Director's Report

Project Name: Edendale Crossing

Description: Request for reconsideration of preliminary site plan

RE: Edendale Crossing- Preliminary Site Plan Review – 4th Review

SCALE	1"	=	30'
SHEET	16	OF	19
KE 2025.010

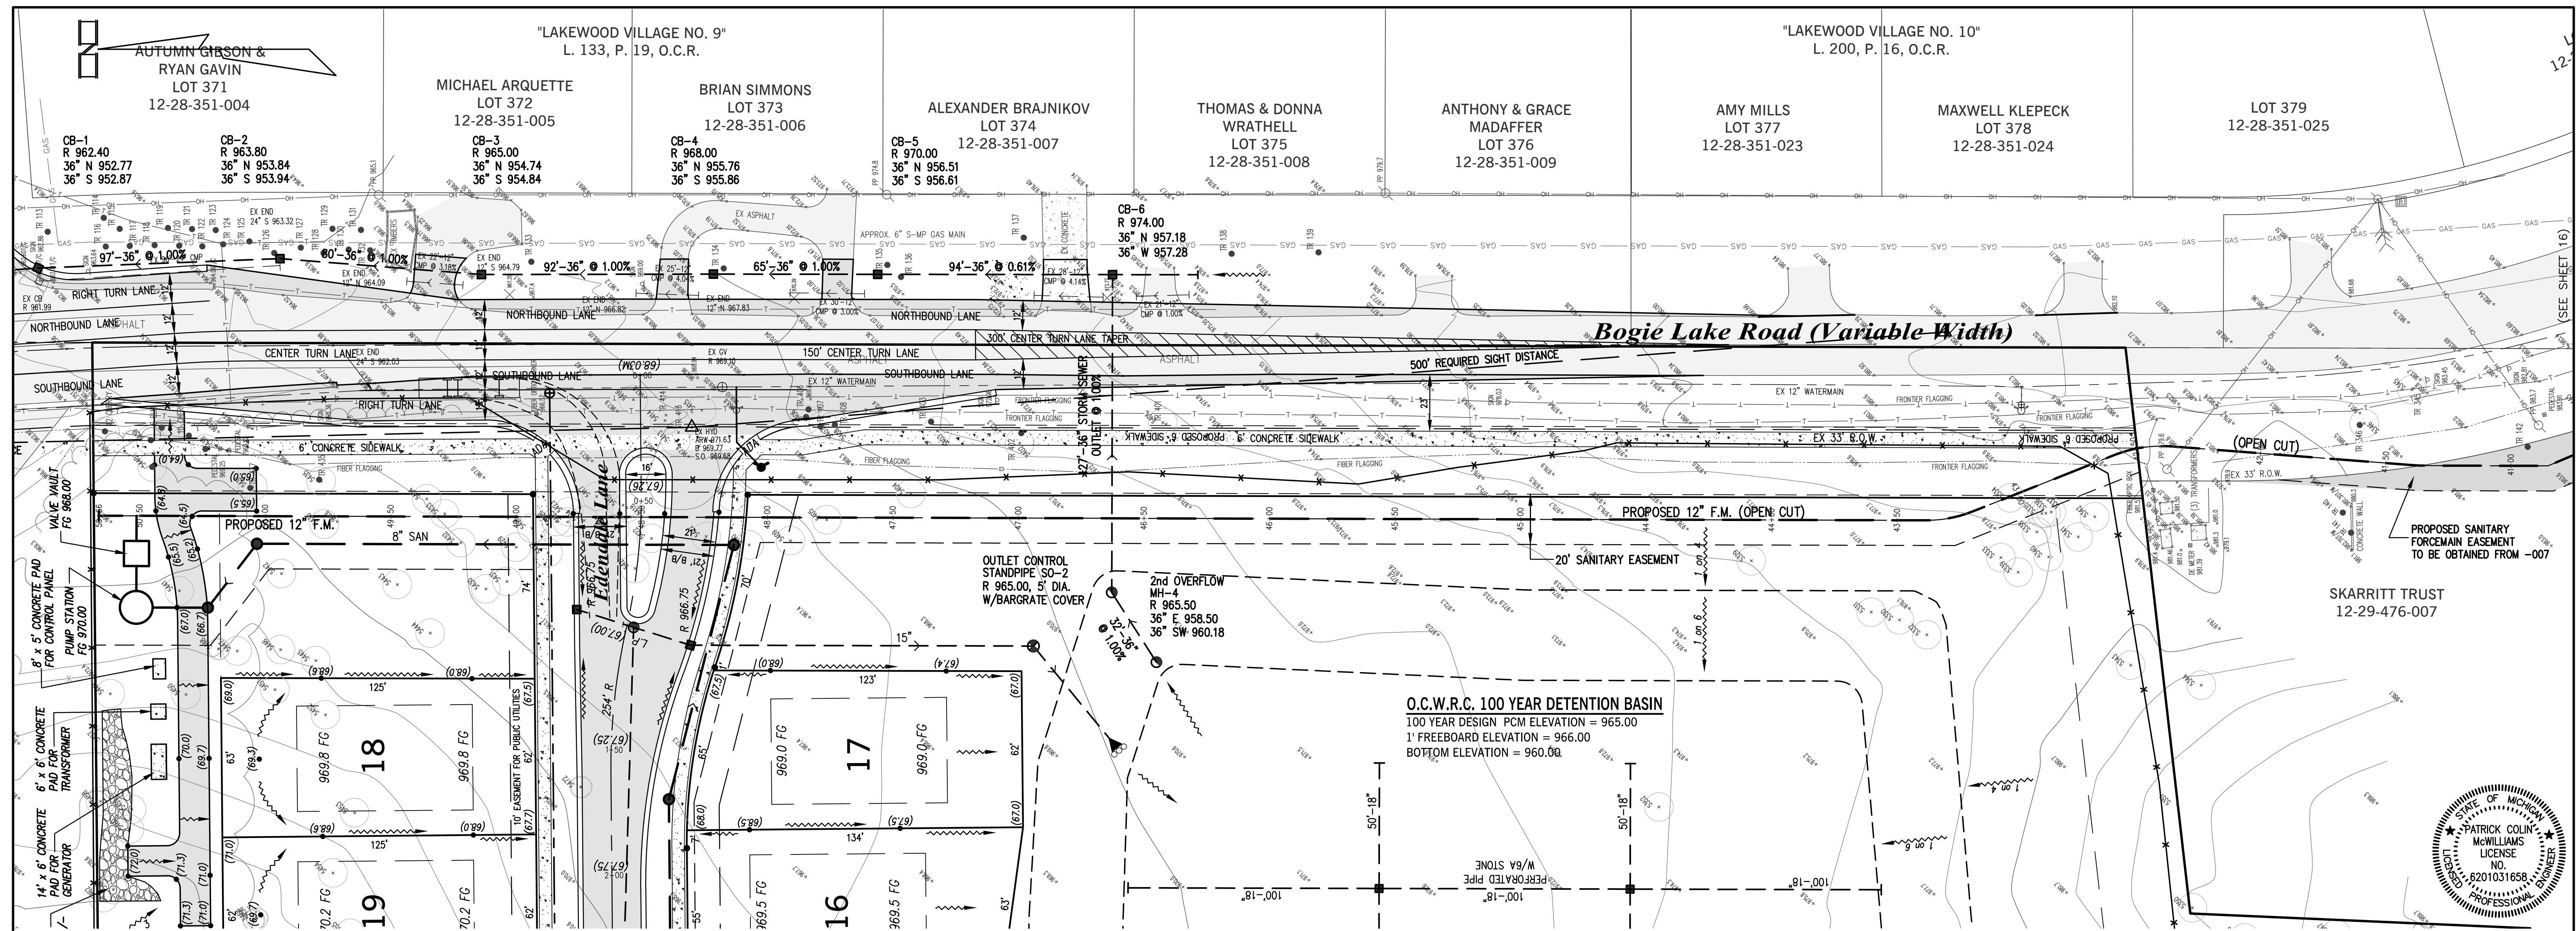
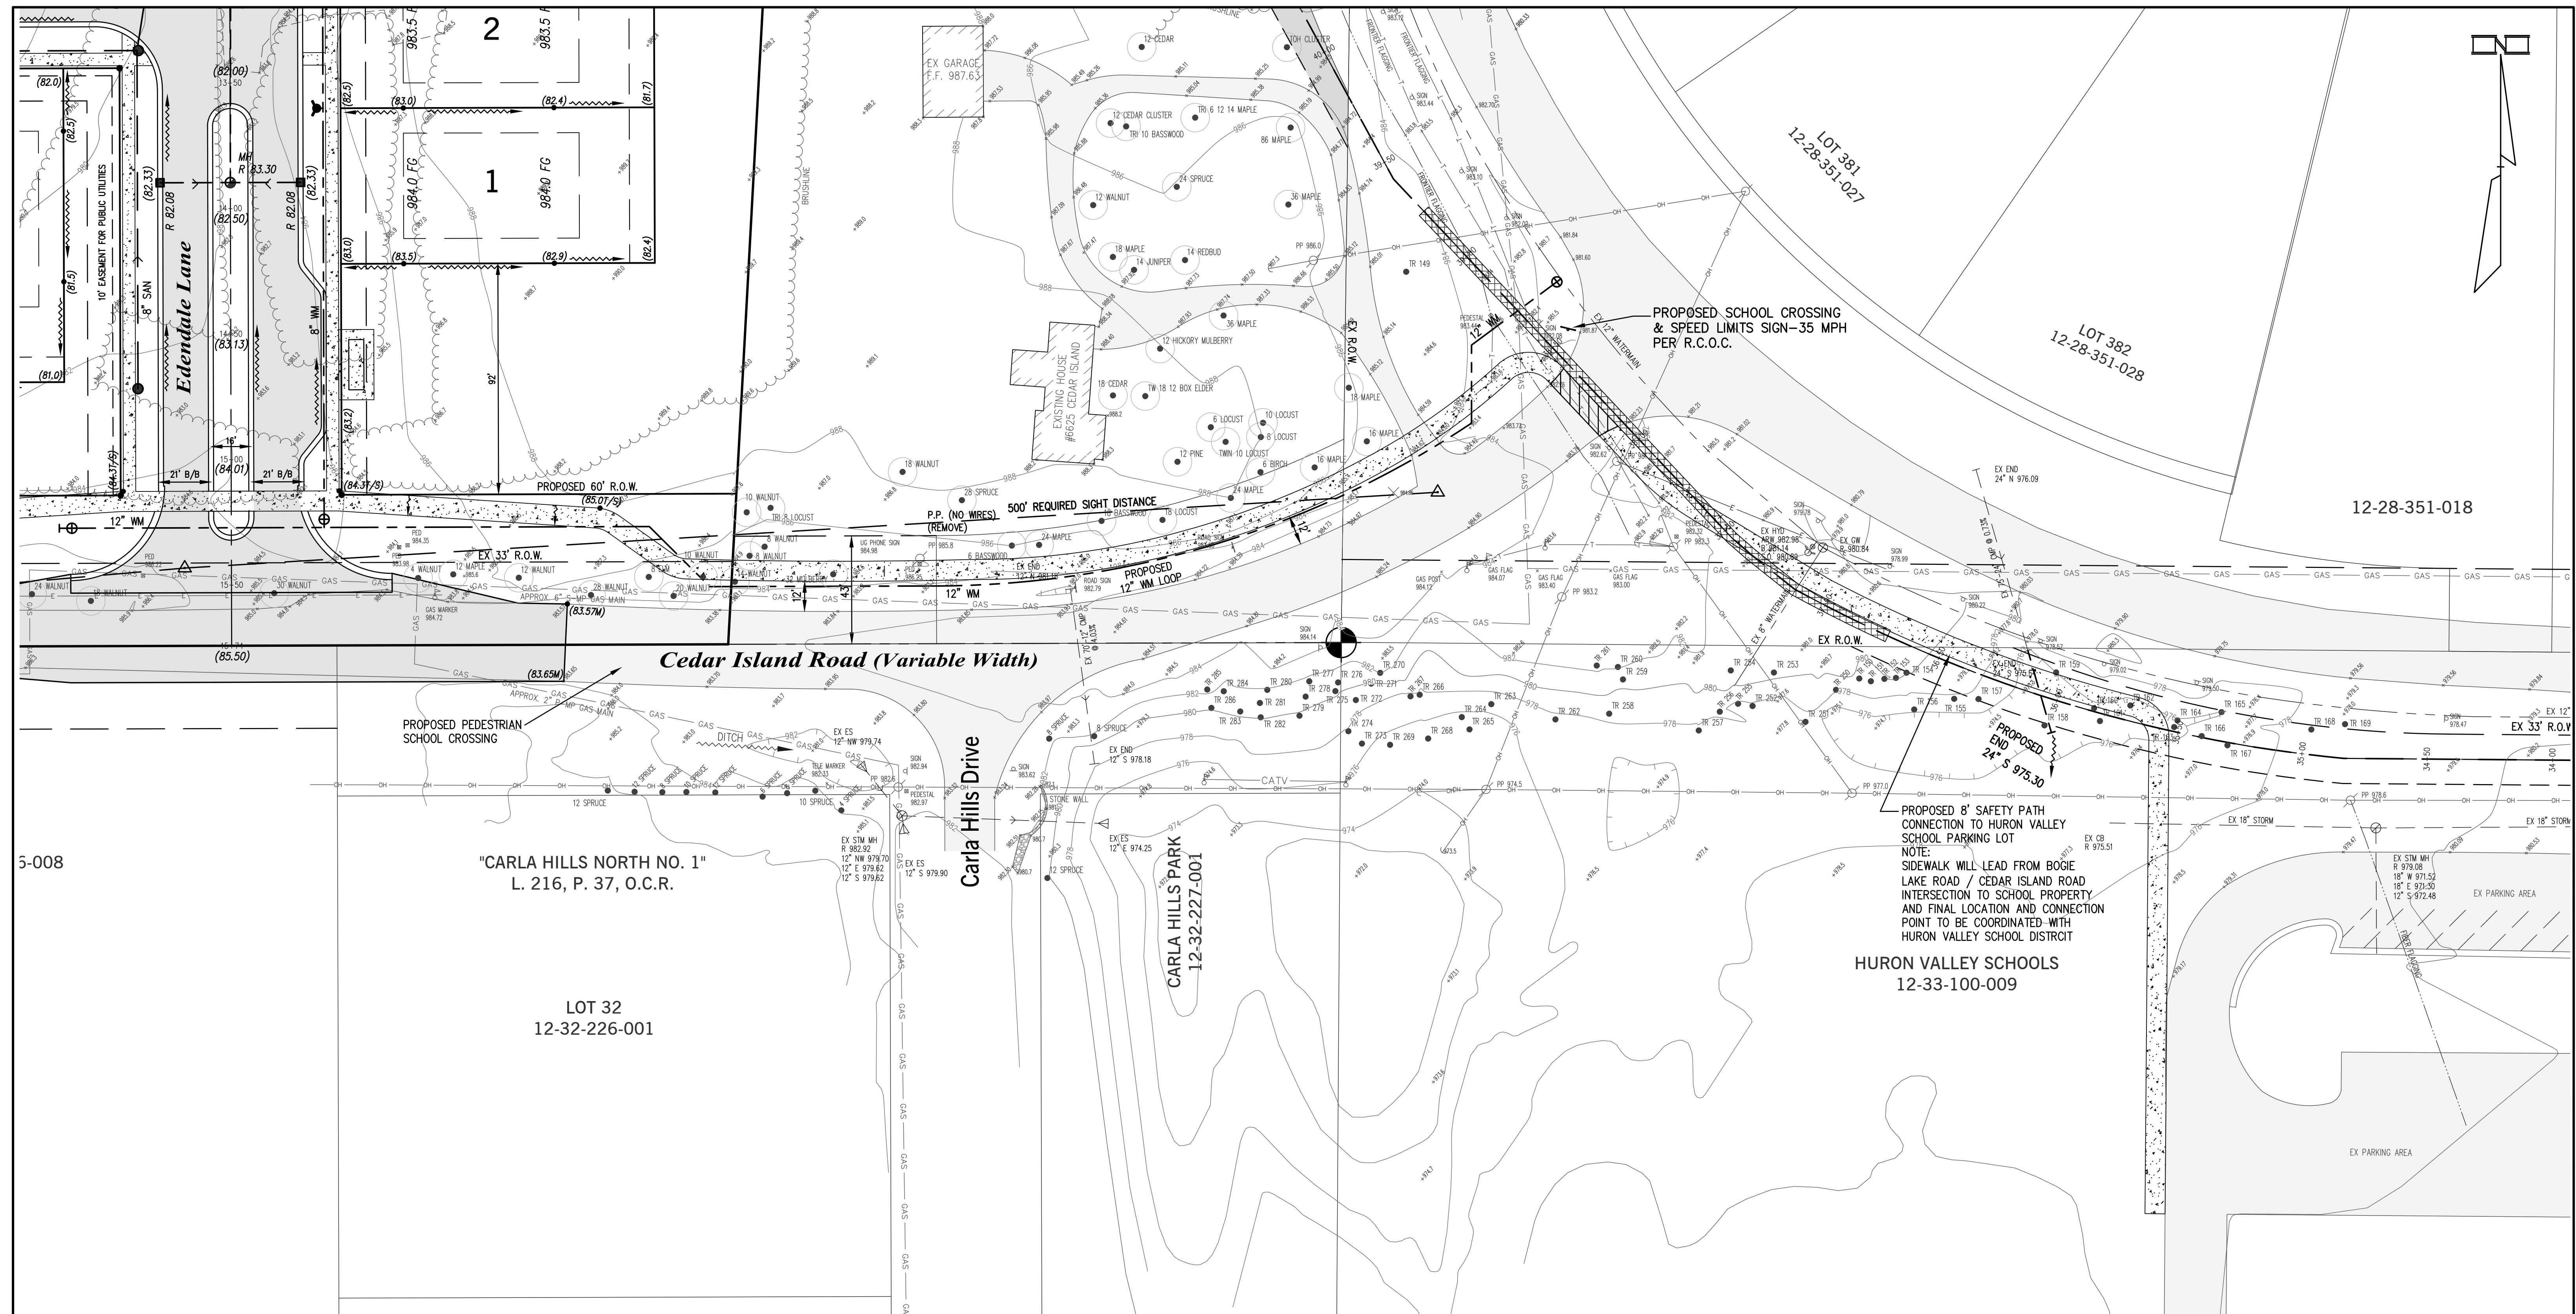
Dimensions for the boulevard access points are provided on Sheet 16. Per the design requirements outlined in table 6.4.C.X, the entrance drive width is sufficient however the exit drive is not wide enough and requires a waiver from the Planning Commission.

Internal sidewalks are shown along all streets as well as cross development pedestrian pathways. These sidewalks are required to be five feet wide as shown on Sheet 16.
